FIELD CHANGE KIT MK-846/WRA-3  
FOR  
CONTROL AND DRIVE  
OF RADIO TRANSMITTING SET AN/WRT-2 OR RADIO SET AN/URC-32  
FROM TRANSMITTER GROUP AN/WRA-3

Prepared by  
HOFFMAN ELECTRONICS CORPORATION  
Military Products Division  
El Monte, California

**PURPOSE:** This field change kit permits operation of Radio Transmitting Set AN/WRT-2 and Radio Set AN/URC-32 at an average power output of 500 watts while receiving rf drive from Transmitter Group AN/WRA-3.

25 March 1965

Figure 1. Schematic/Interconnecting Diagram for AN/WRT-2

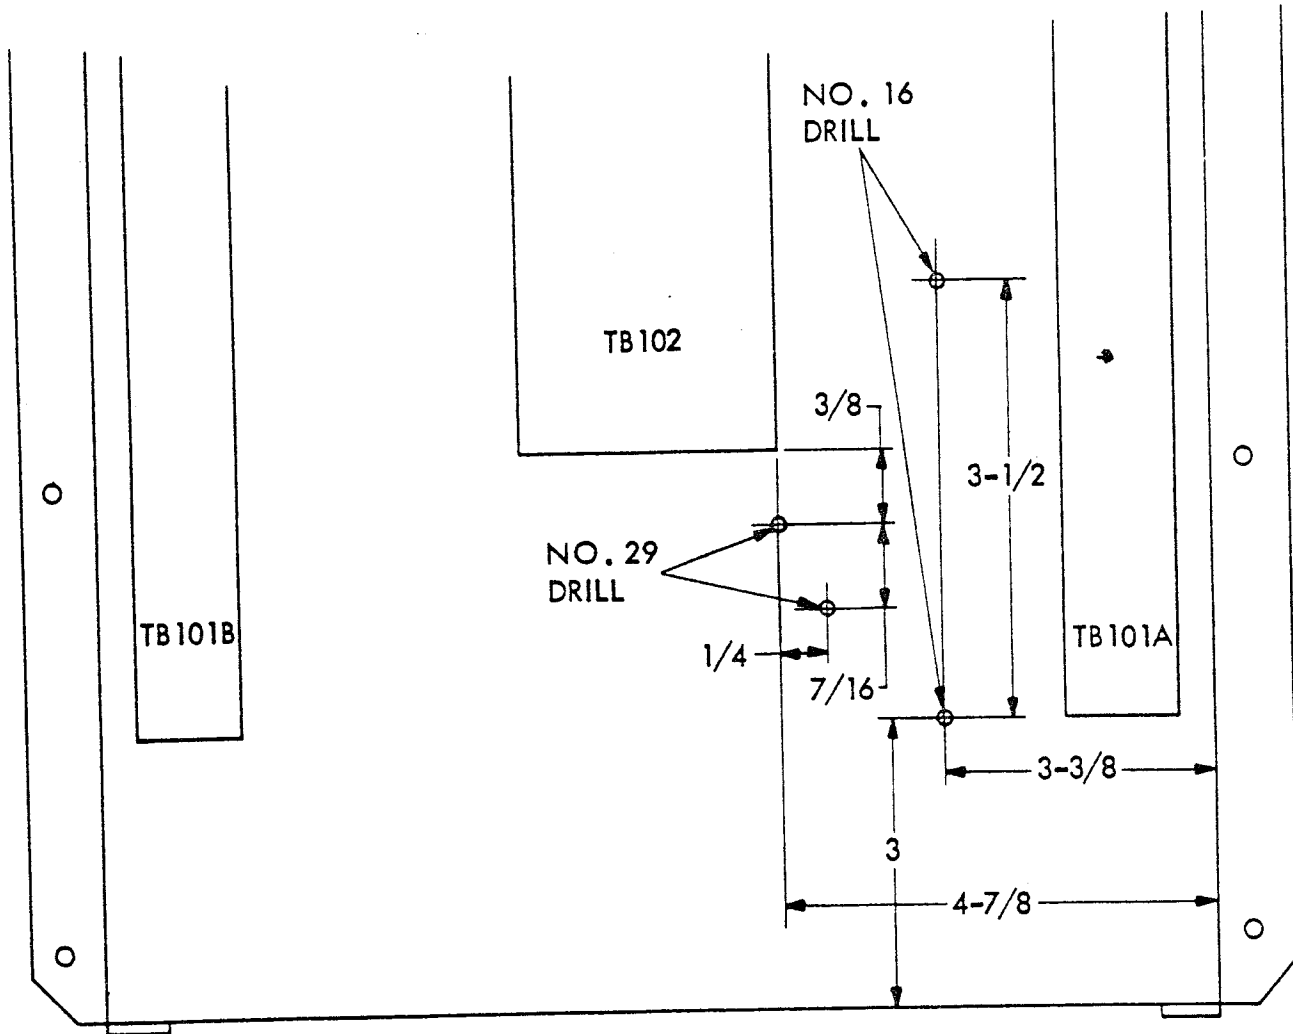
Attach terminal lug (Item 23) to cable shielding and to each of the wire leads. The length of this cable depends on the mounting location of the Transmitter-Transfer Control. See figure 1.

4. Fabricate cable assembly W2 by attaching a connector plug (p/o Item 14) to each end of the cable (Item 29). The length of the cable depends on the location of Radio Transmitting Set AN/WRT-2 in respect to Transmitter Group AN/WRA-3. See figure 1.

The blue and brown leads are spares and have no electrical significance. See figure 1.

24. Fabricate cable assembly W5 from bulk cable (Item 31) by attaching three terminal lugs (Item 23) to one end of cable (WRT-2 end). Attach a lug to the black wire, white wire, and cable shielding. Attach three terminal lugs (Item 24) to the other end of the cable assembly W5 (WRA-3 end). Attach a lug to the black wire, white wire, and cable shielding. The length of this cable depends upon mounting location of Transmitter Group AN/WRA-3 and Radio Transmitting Set AN/WRT-2. Route cable W5 into the Terminal Junction Box of Electrical Equipment Cabinet CY-2558/WRT-2 and attach the white lead to TB1-3. Attach the black lead and the cable shield to TB1-7. See figure 1.

Figure 2. Connector and Terminal Board Mounting Dimensions, AN/WRT-2

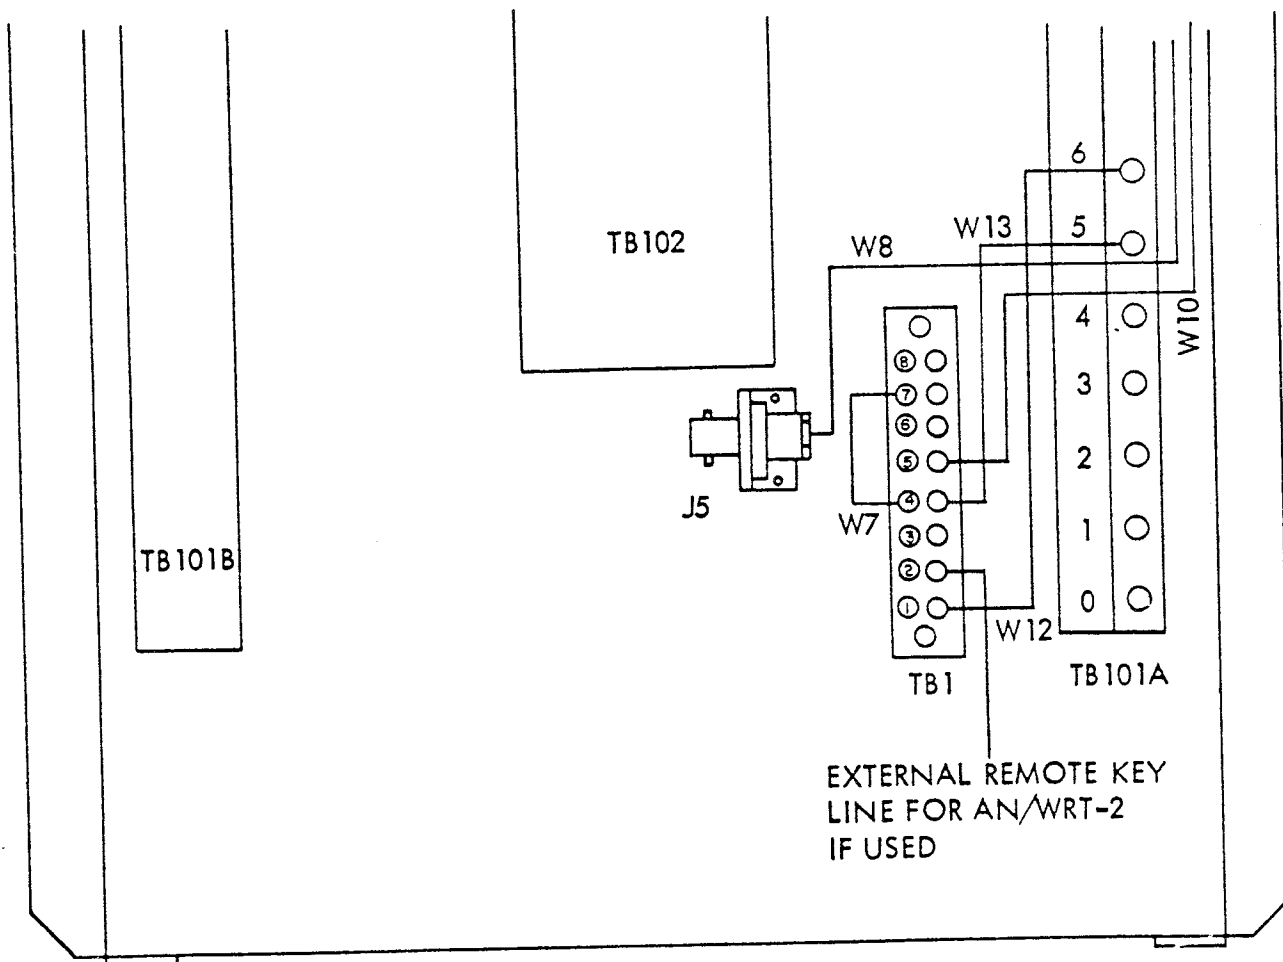
7. Block the Terminal Junction Box of Electrical Equipment Cabinet CY-2558/WRT-2 of Radio Transmitting Set AN/WRT-2 for drilling. See figure 2 for dimensions and locations of holes. Drill one hole in each mounting-hole pattern and use terminal board TB1 (Item 2) and connector bracket (Item 3) as templates for drilling the other holes. Deburr the drilled holes. Mount the terminal board and connector bracket using hardware kit (Item 25) as required. Mount connector J5 of W8 (Item 17) on receptacle bracket. See figure 3.

Figure 3. Connector and Terminal Board Mounted, AN/WRT-2

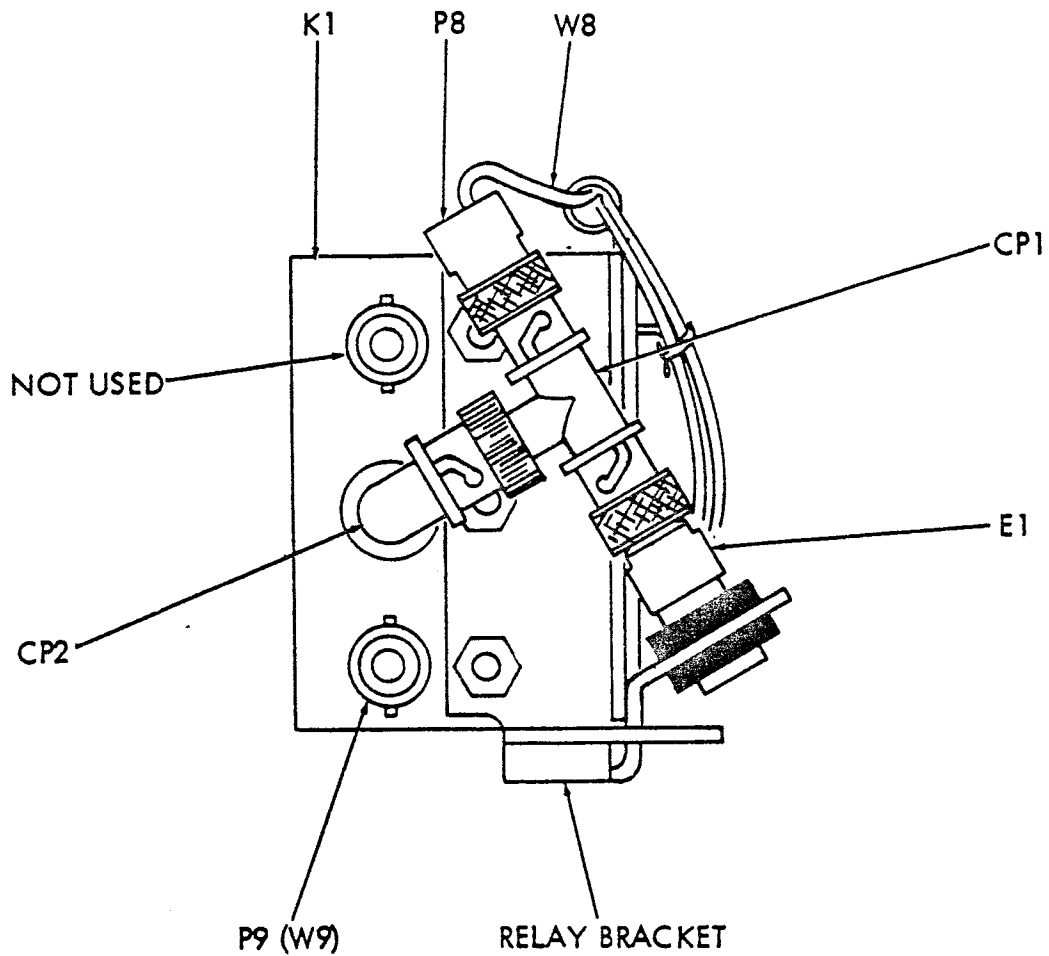
10. Connect terminal lug end of wire W10 (Item 19) to terminal 5 of terminal board TB1 on Terminal Junction Box. See figure 3. Route both wire W10 and coaxial cable W8 along the existing cable from TB101A on Terminal Junction Box, up the cabinet trunk cable and along the flexible traveling cable to coaxial relay K1, installed in step 9, in Radio Frequency Amplifier AM-2121/WRT-2. See figure 2-8 of Technical Manual NAVSHIPS 93319(A) (Item 32). Tie wire W10 and cable W8 to existing cables at appropriate intervals with lacing cord. Coaxial cable W8 is routed across the back of the unit. See figure 3.

21. Remove any existing remote keyline for the AN/WRT-2 connected to TB101A terminal 6 of Terminal Junction Box of Electrical Equipment Cabinet CY-2558/WRT-2, and transfer to terminal 2 of TB1. Connect wire W12 (Item 21) between terminals TB101A-6 and TB1-1. See figure 3.

22. Connect wire W7 (Item 16) across terminals 4 and 7 of TB1. Connect wire W13 (Item 22) between TB101A-5 and terminal 4 of TB1. See figures 1 and 3.

29. Plug P2, the unattached end of cable W2, to J5 of cable W8. Cable W8 was installed in step 7. See figures 1 and 3.

Figure 4. Relay and Connector, Assembled, AN/WRT-2

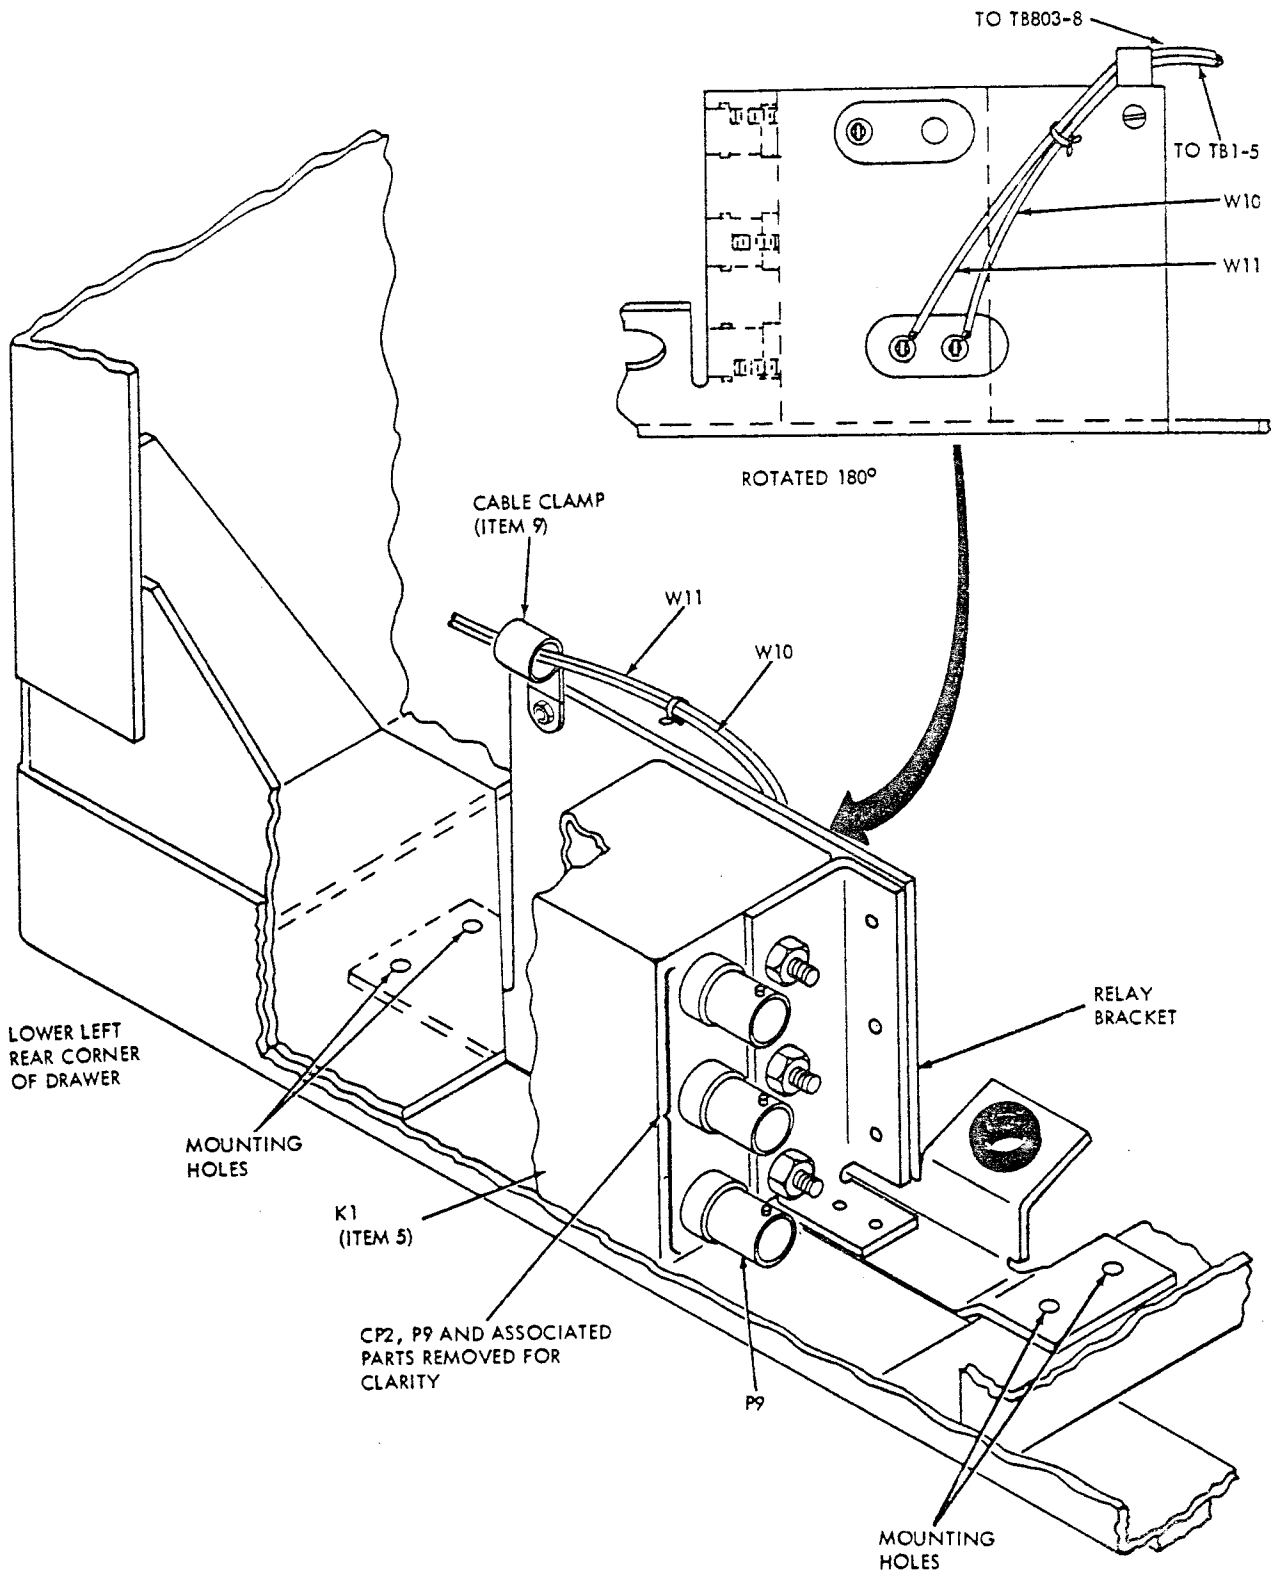
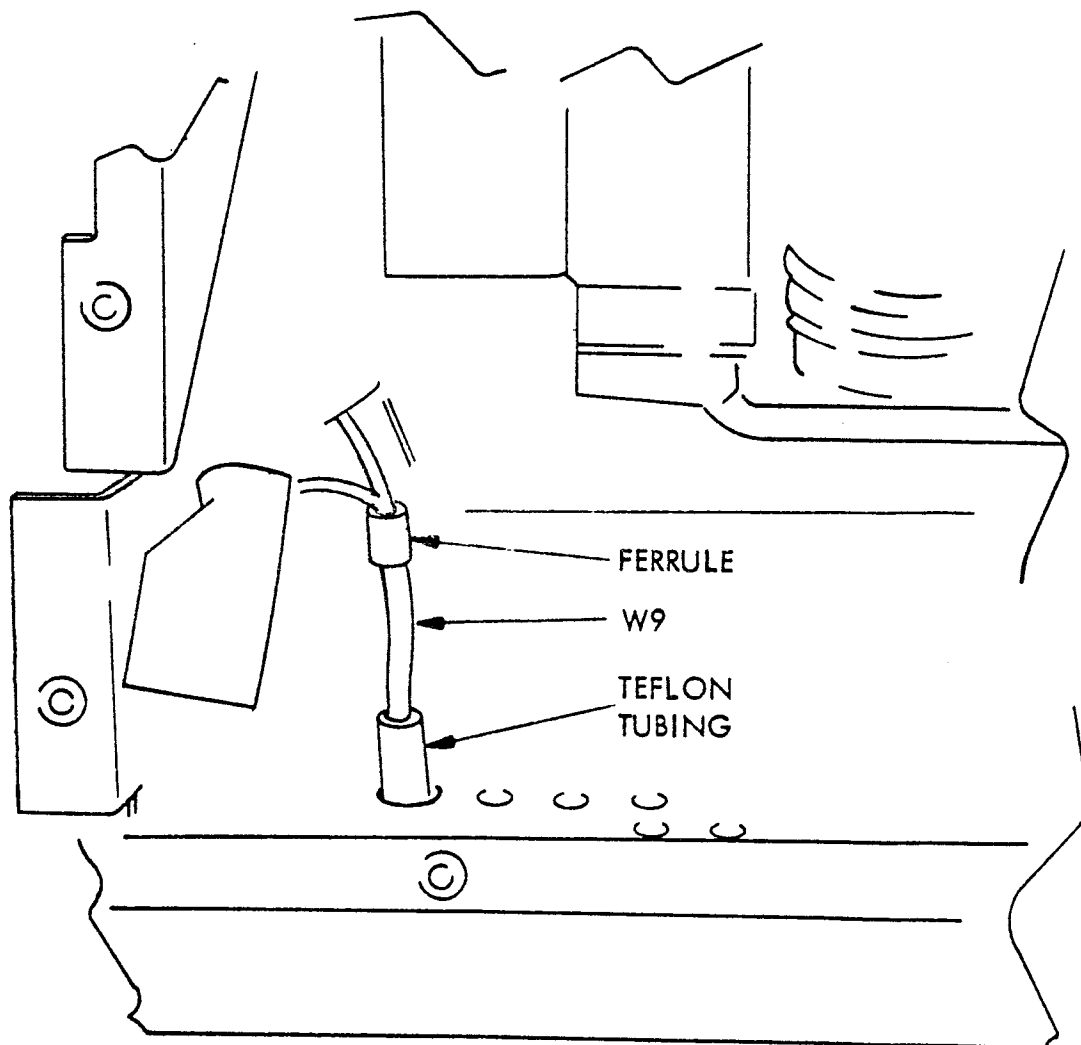
8. Assemble items 4, 5, 6, 7, and 8 as shown in figure 4, using hardware kit (Item 25) as required.

11. Plug connector P8, of cable assembly W8, into coaxial adapter CP1. See figure 4. Solder the free end of wire W10 to one of the relay coil terminals of relay K1. See figure 5.

16. Prepare coaxial cable in accordance with the instructions in figure 7. Attach connector P9 supplied with cable assembly W9 (Item 18) to the cable and plug connector P9 into coaxial relay output receptacle. See figures 1 and 4.

Figure 5. Relay and Connector, Mounted, AN/WRT-2

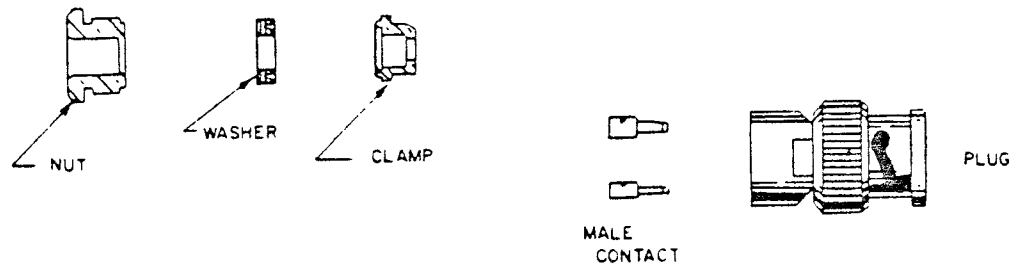
9. Release the captive screws on the front panel of Radio Frequency Amplifier AM-2121/WRT-2 of Radio Transmitting Set AN/WRT-2. Withdraw and lock the drawer in the open position. Using the relay bracket (Item 4) as a template, mark, drill, counter-sink and deburr mounting holes, as indicated in figure 5. Attach the relay bracket and associated items (assembled in step 8) to the frame, using hardware kit (Item 25) as required.

Figure 7. Cable Preparation

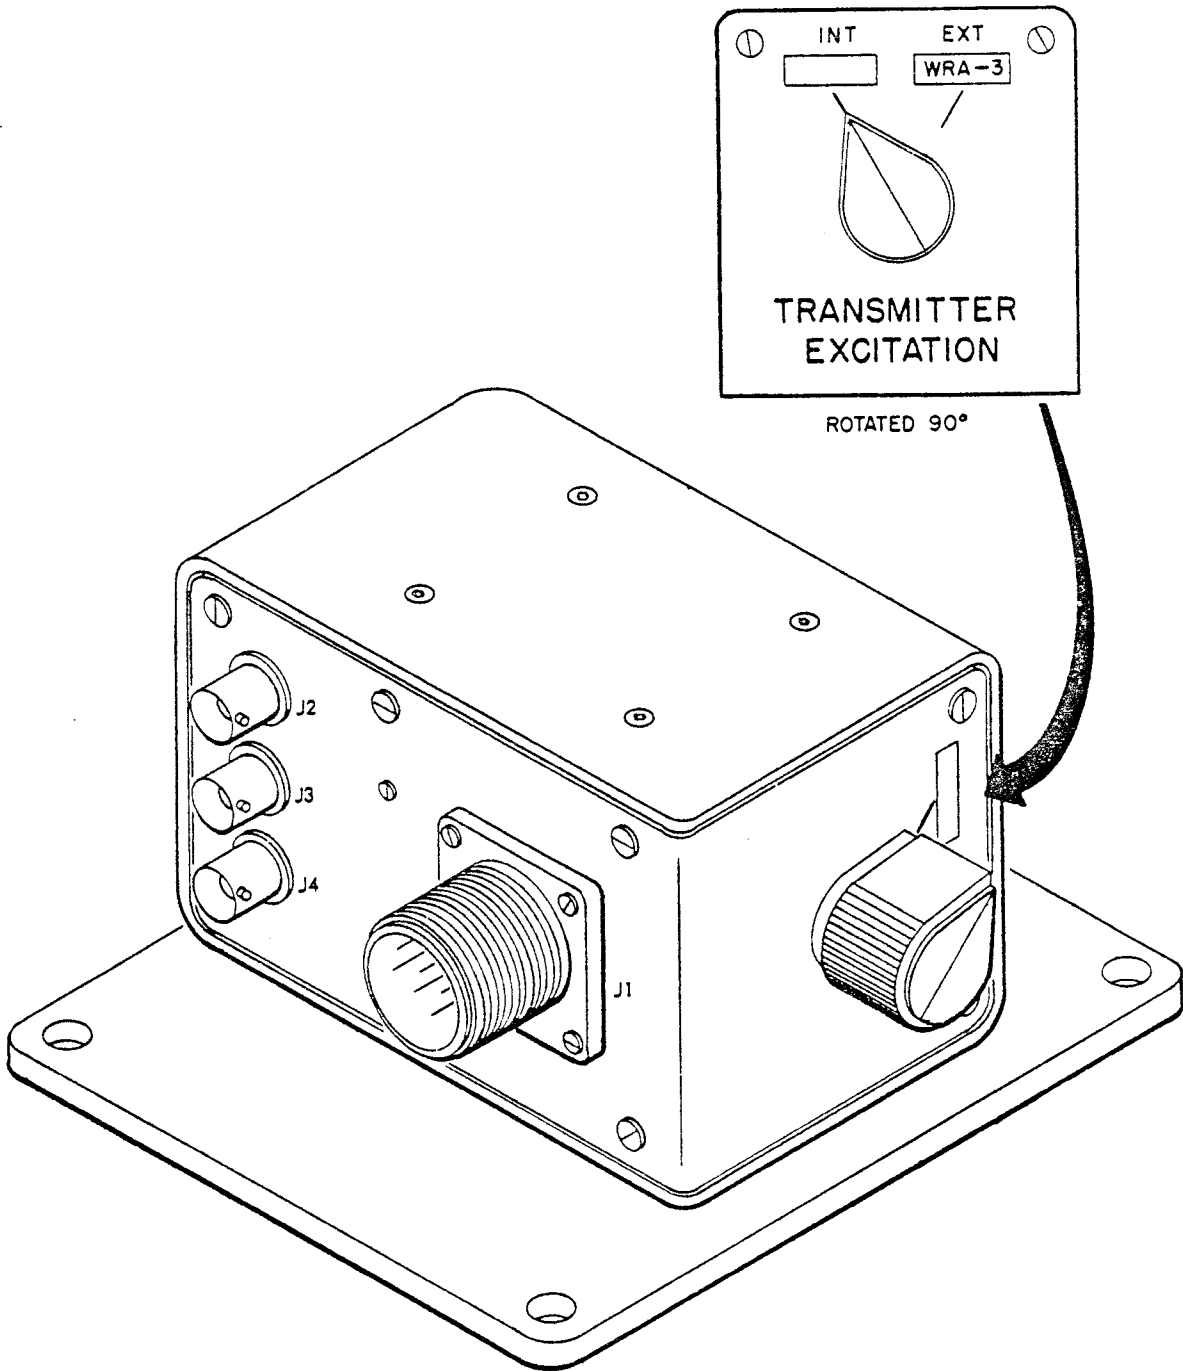
1. Cut off end of cable square and remove jacket  $5/16$ " from end. Do not nick braid.

4. Flare back braid trim if necessary, cut dielectric  $1/8$ " from braid. Do not nick inner conductor. Cut off inner conductor  $7/64$ " from dielectric.

5. Solder contact on inner conductor. Remove excess solder. Do not over heat dielectric as it will become swollen and will not enter body and insulator properly.

6. Insert cable and hardware into connector body either jack or plug. Make sure gasket is properly seated on sharp edge of clamp. After nut is started tighten with wrench.

Figure 8. Transmitter-Transfer Control C-6562/WRA-3

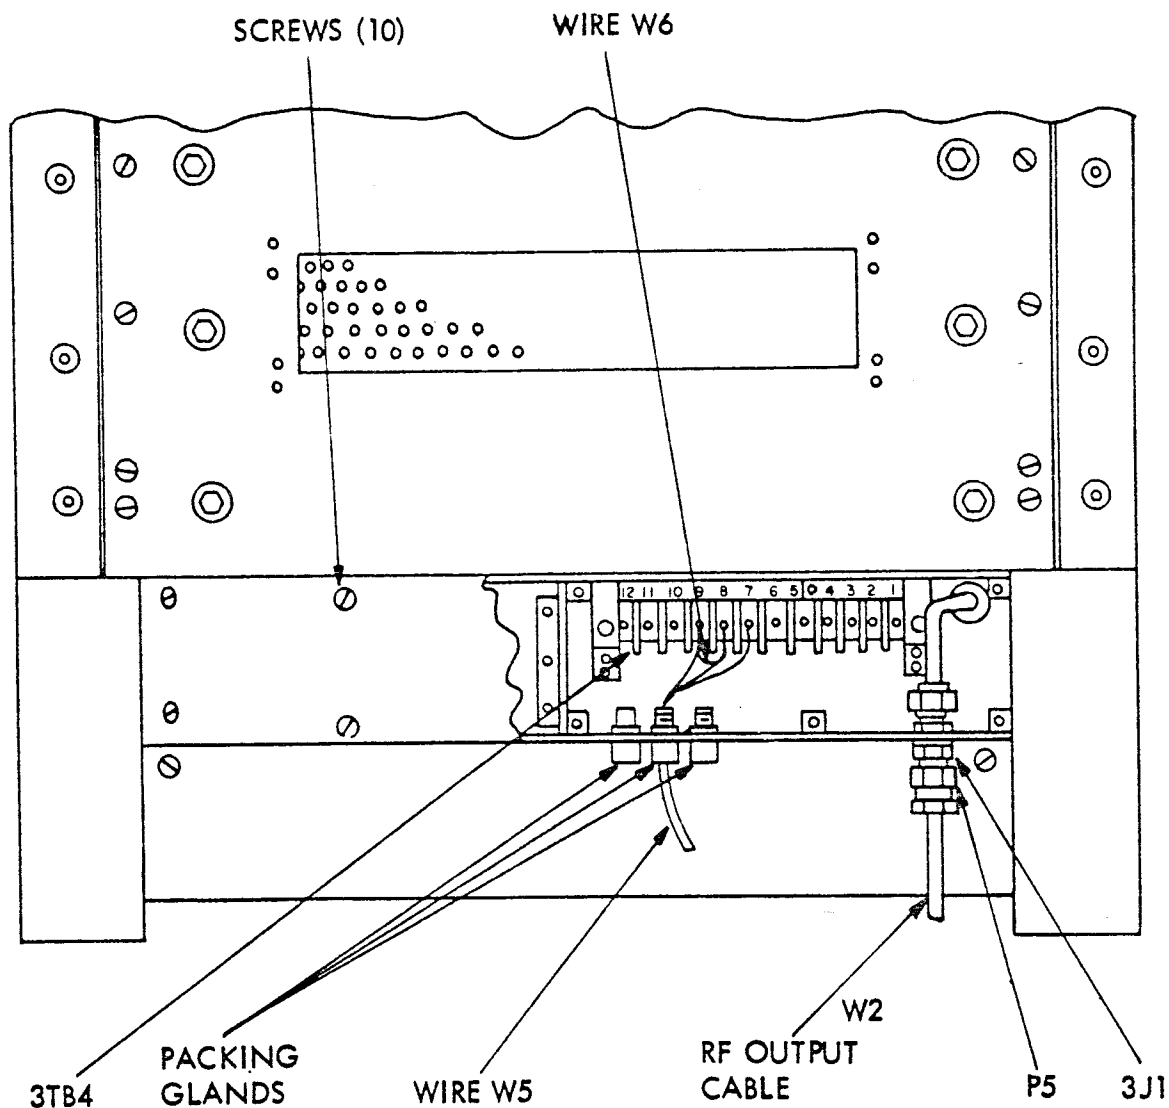
23. Plug connector P1, of cable W1, fabricated in step 3, into 6J1 of the Transmitter Transfer Control (Item 1). See figure 8. Route cable W1 (terminal-lugs end) into Terminal Junction Box of Electrical Equipment Cabinet CY-2558/WRT-2 and attach the cable leads as follows:

7. Disconnect and transfer any external remote key lines from TBF-8 to TBG-8 of Interconnecting Box J-1007/U.
8. Plug P1 of cable assembly W1, fabricated in step 3, to 6J1 of the Transmitter-Transfer Control. See figures 8 and 10.
